DEVELOPMENT COMMITTEE

Report of the Corporate Director of Place

Reference	PA/20/01914
Site	Armoury House, 7 Gunmakers Lane, London, E3
Ward	Bow East
Proposal	Two storeys extension above the existing building with three self-contained flats, cycle parking storages and new bins storage for new residences and associated landscaping work in the external areas.
Recommendation	Grant planning permission with conditions
Applicant	Avon Ground Rents Limited
Architect	Brooks Murray Architects
Case Officer	Katie Cooke
Key dates	<ul style="list-style-type: none">- Application registered as valid on 09/09/20- 1st round of public consultation finished on 15/10/20- A further round of consultation was carried out for a 2 weeks period, as a result of additional information provided and finished on 7/12/20

Figure 3: Contextual elevations showing the proposals against Albany Works to the south and Gate House to the north

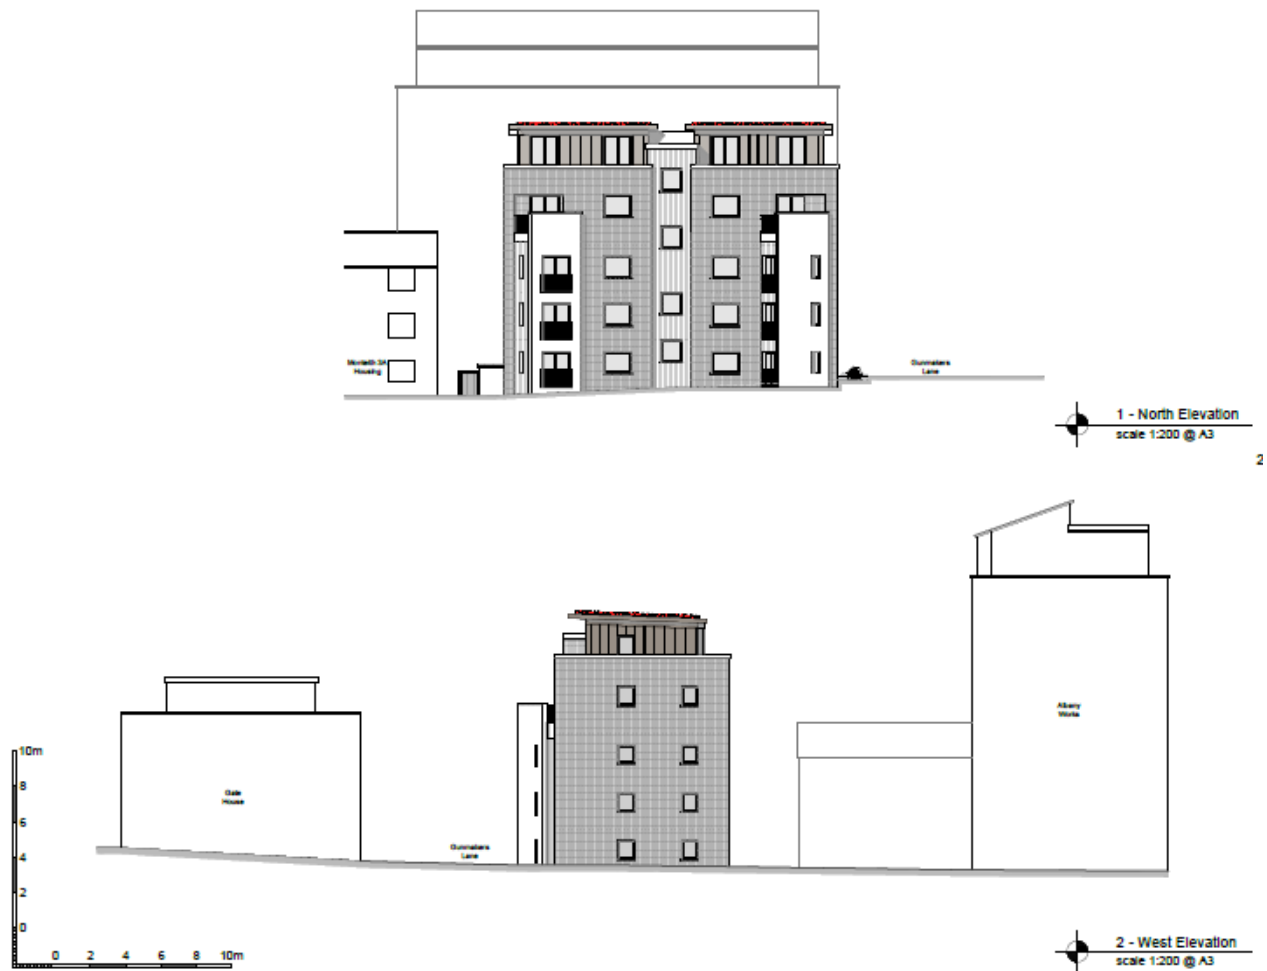
- 7.48 With the proposed upper extension, Armoury House would remain subservient to Albany Works as it would be 2 storeys lower (or 1 storey lower if discounting the below ground level of Albany Works). This is illustrated in the contextual elevations below,
